# Building Inspection Report

FANGS BUILDING INSPECTIONS

**Lotxx Evesham Drive, Point Cook, VIC, 3030**

Inspection Date:        01 Mar 2019

## Articulation Joints

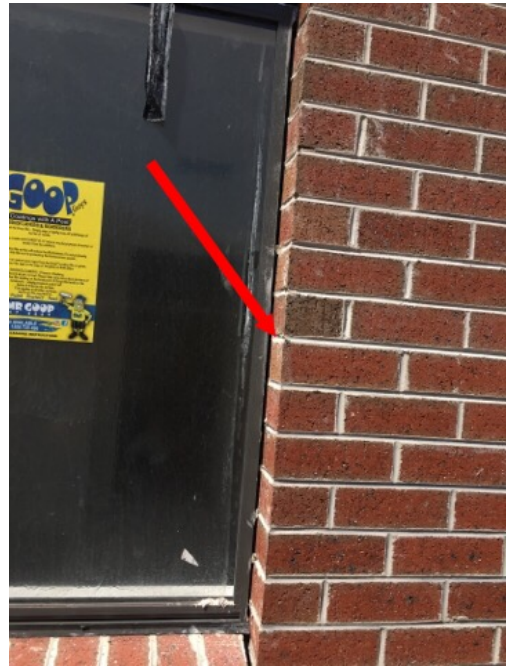
Construction joints are not sealed and abflex must be inserted before caulking

All of the AJ's must be stripped, cleaned of all non-compressive material and then presented for inspection and only then sealed.

Please refer to AS 4773.2, page 32, section 7.1, and the BCA for further details

### Drainage and Sewer

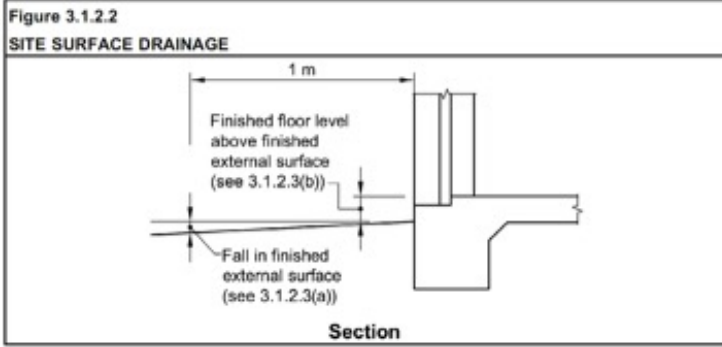
Downpipe appears to be not connected during the inspection  
No capping to the drainage pipes
